WILLIAMSON COUNTY, TEXAS

CHANGE ORDER NUMBER: 1

Project: 1805-229
 Bagdad Road at
 Roadway: CR 278
 CSJ
 Number: _____

Bagdad Road at CR 278 Williamson County Project No. 1805-229

SHEET L7 OF 29

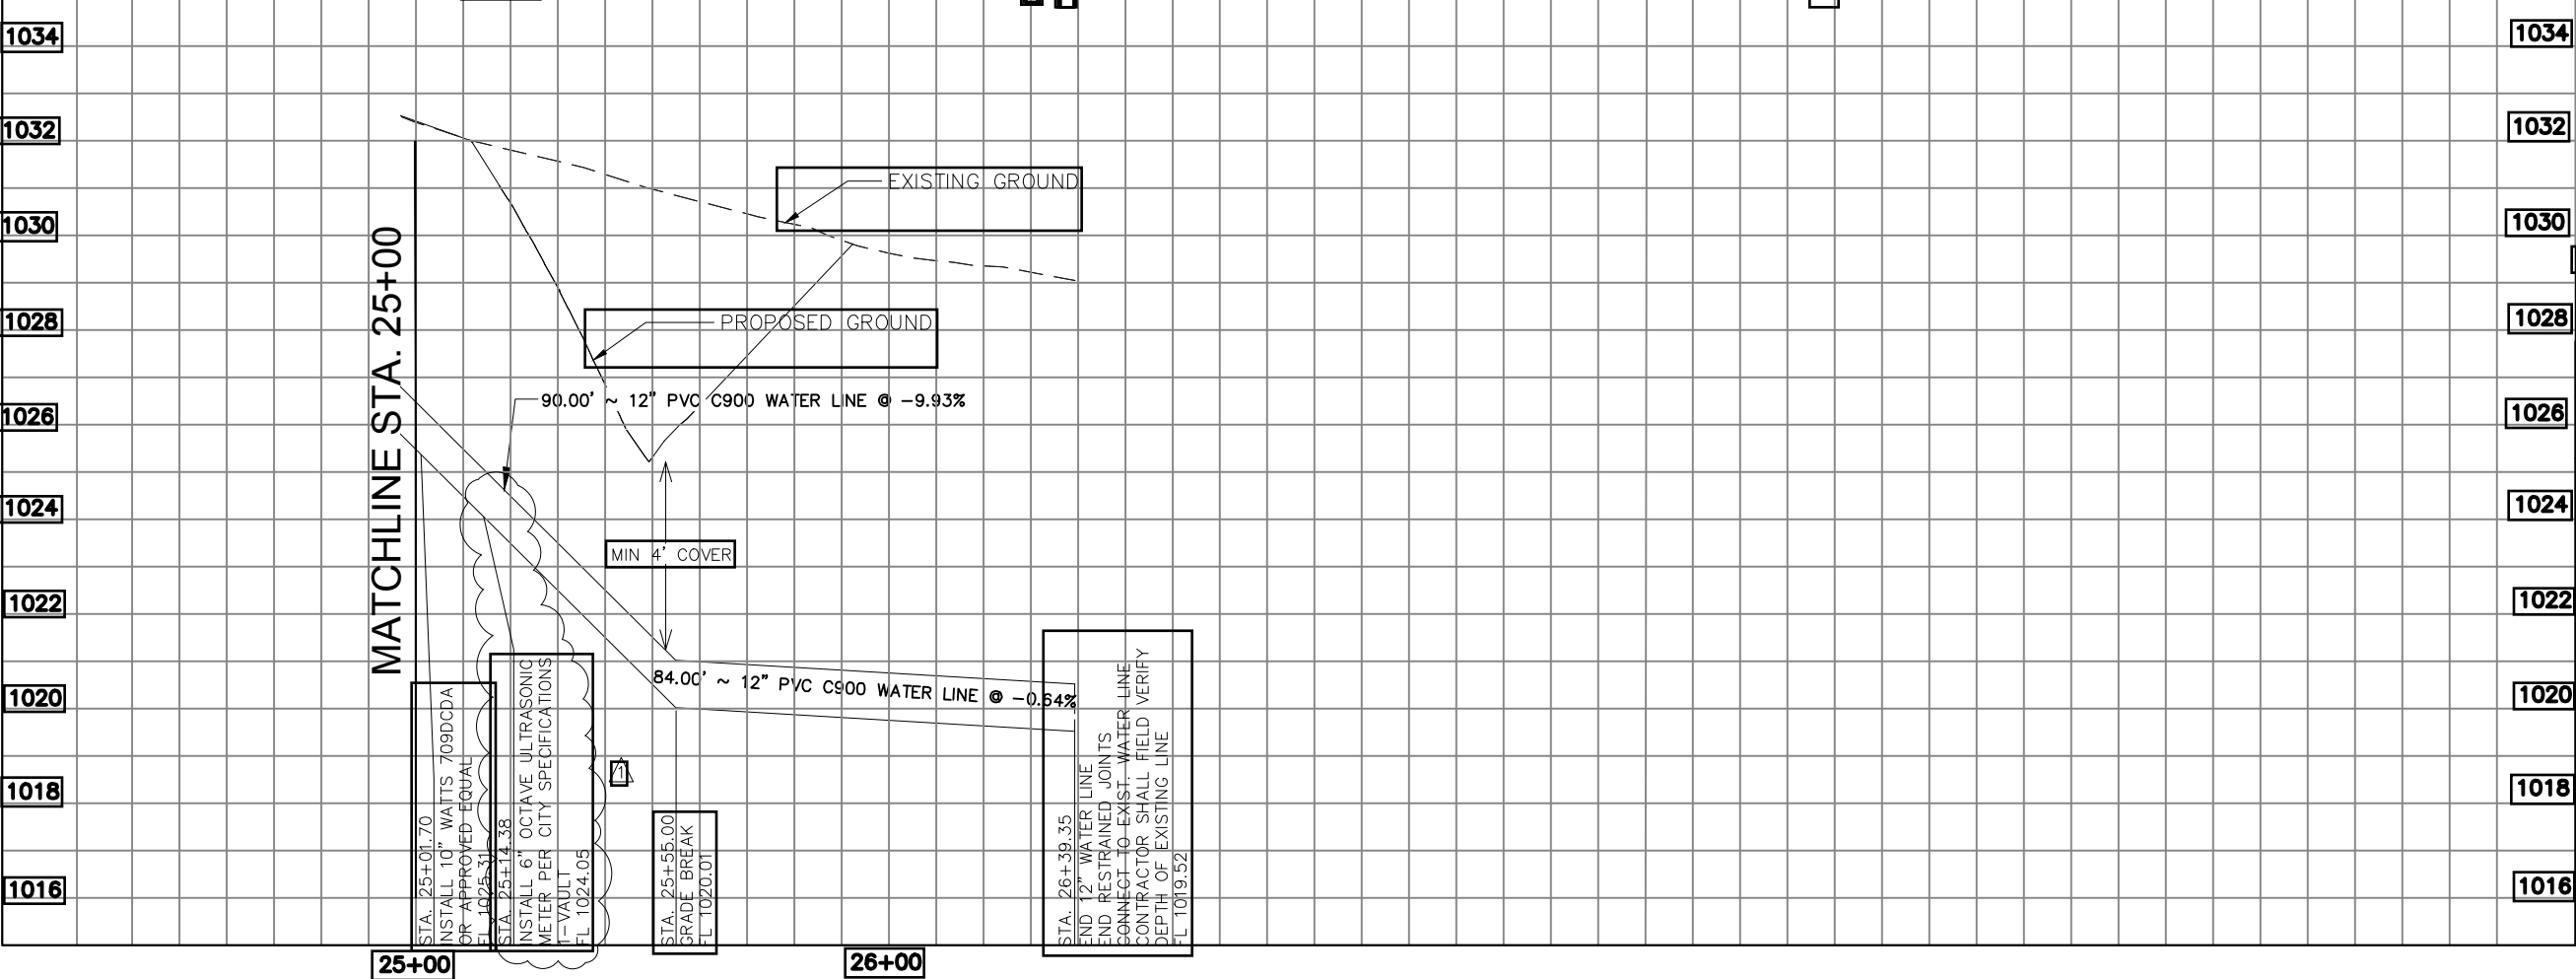
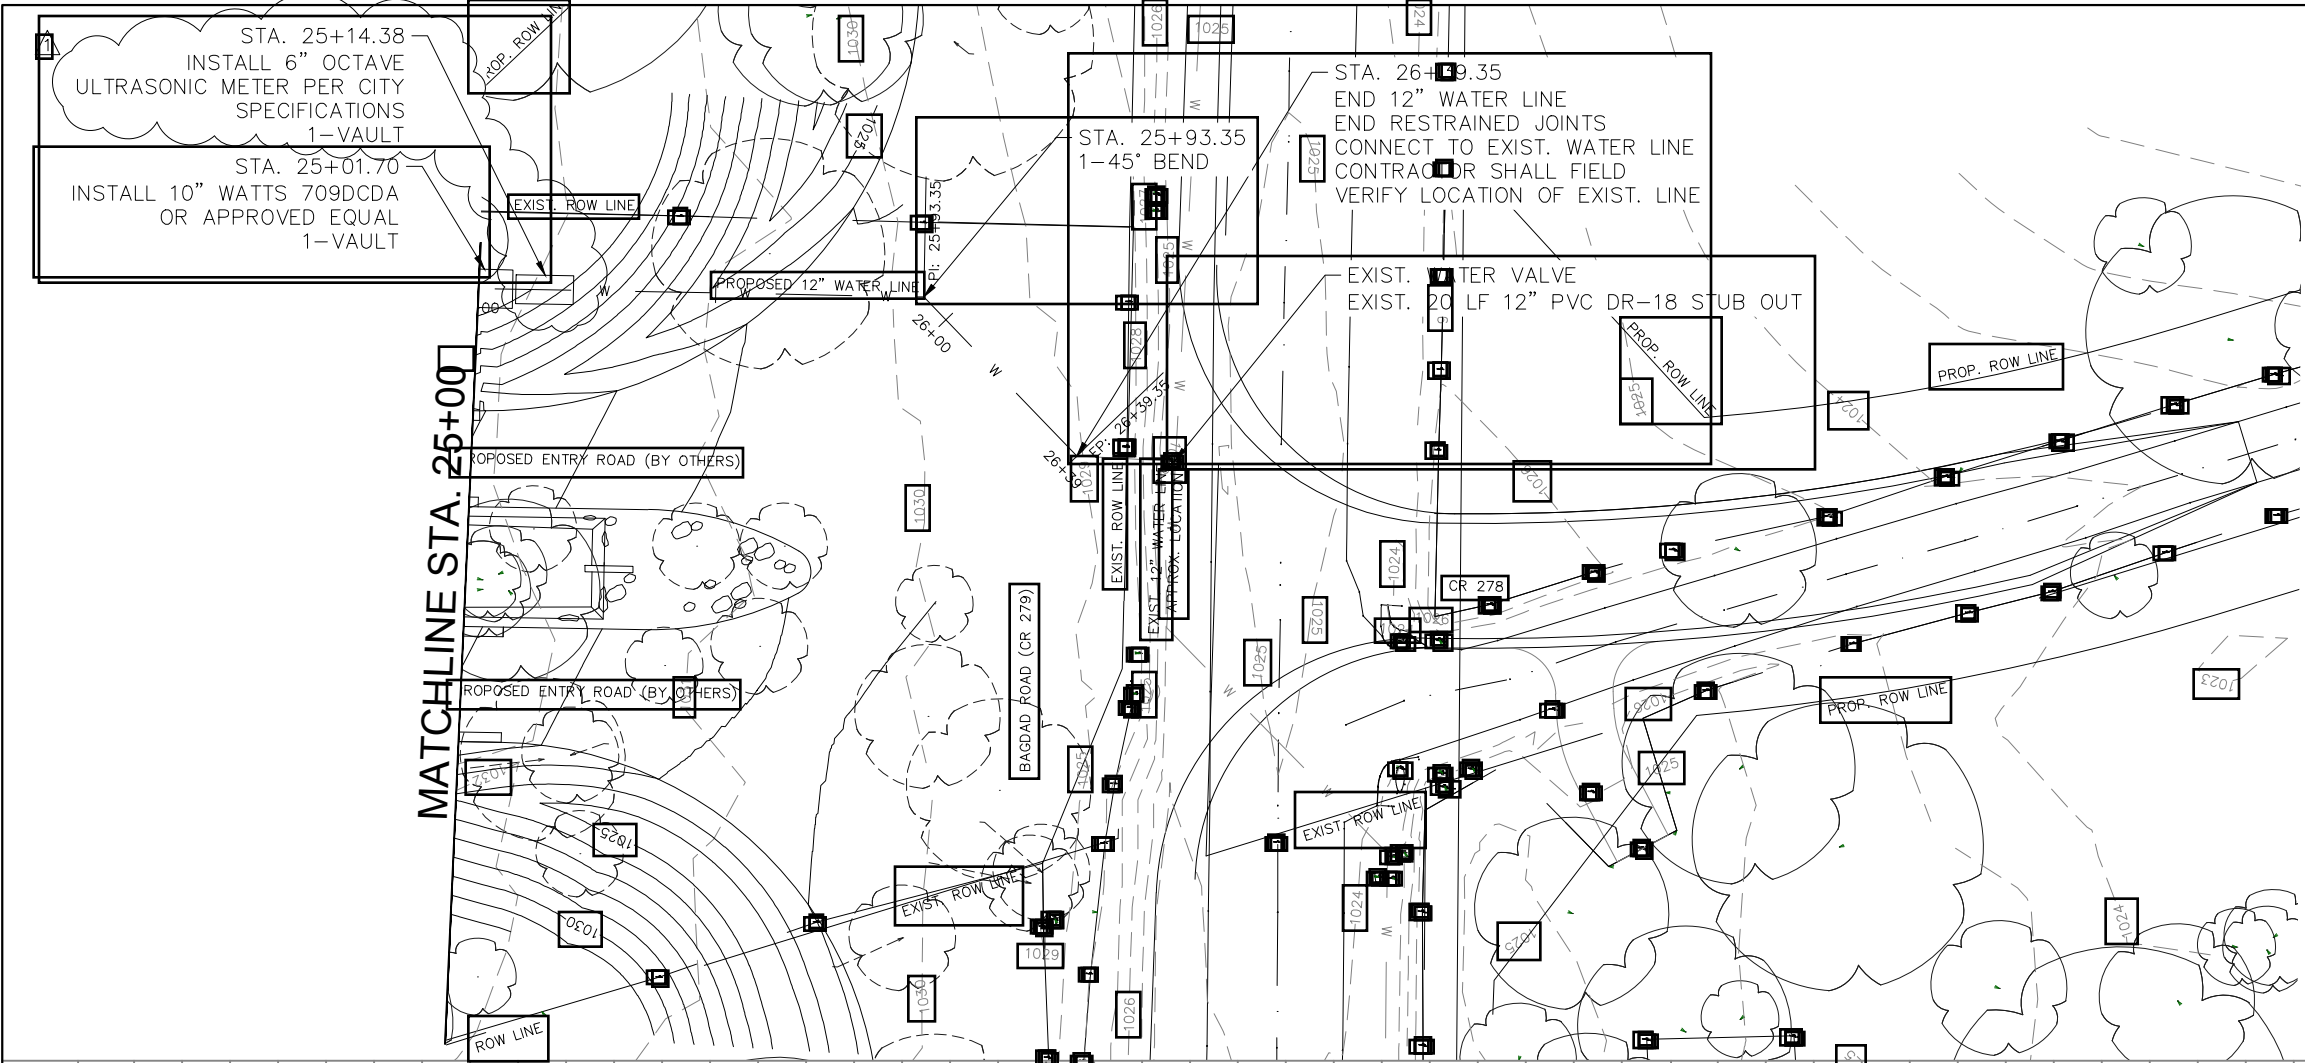
1A: Design Error or Omission. Incorrect PS&E. This change order adds new bid items for the design revision to add a service meter to the 12" waterline. This change order also replaces the DR-18 waterline pipe called for in the plans with a DR-14 pipe inside the park. **3F: County Convenience. Additional work desired by the County.** This change order adds new bid items for the connection of 12" waterline to the waterline installed by others at the west end of the park road, for additional tapping saddle for landscape irrigation, and 4" PVC sleeves under roadway for future irrigation and electrical needs in the park. This change order also replaces the Type 1 ground box with a Type D ground box for the communication line along the park road.

Water Line: This Change Order adds a service meter and replaces DR-18 pipe with DR-14 pipe for the 12" waterline inside the park as required by the Engineer. This Change Order compensates the Contractor for additional work and material, in order to connect the 12" waterline to the waterline installed by others at the west end of the park road. This Change Order adds an irrigation stub-out on the 12" waterline and 4" PVC sleeves under the roadway for future irrigation needs inside the park.

REV	DATE	DESCRIPTION
1	4/24/19	ADDED MASTER METER

Traffic Operations Division Standard	
ELECTRICAL DETAILS GROUND BOXES			
ED(4) - 14			
FILE: ed4-14.dgn	DN: TxDOT	CK: TxDOT	DW: TxDOT
©TxDOT October 2014	CONT	SECT	JOB
REVISIONS	DIST	COUNTY	ITS-8

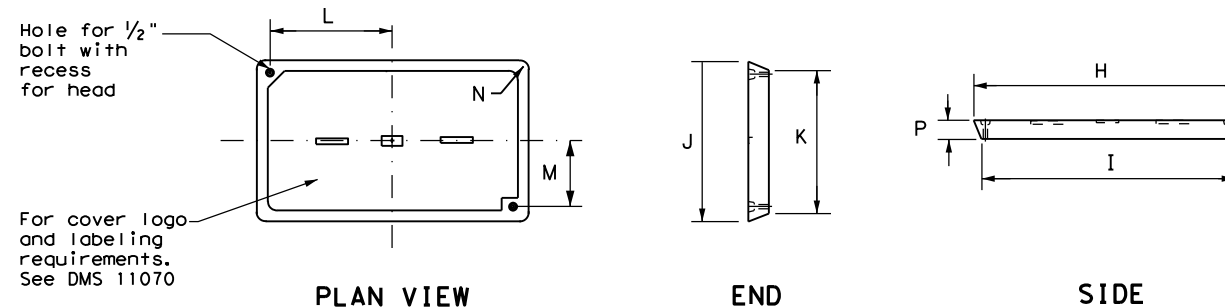
Communication Line: This Change Order also replaces the Type 1 ground boxes with Type D ground boxes per RFI 6 response. Type D ground boxes are available at a lower cost and still meet the project requirements.

Type D ground boxes are a third the cost of the ITS ground boxes originally specified. More boxes may be needed because the distance between boxes should be 300 - 350 ft for wire pulls instead of the 800 feet called for in the plans. Is it acceptable to use the Type D ground boxes along the Park Road and on the remaining portions of the project?

The Type D ground boxes can be used as an alternative to the large concrete ground boxes called out in the plans for the ITS layout. See the attached details ED(4)-14.
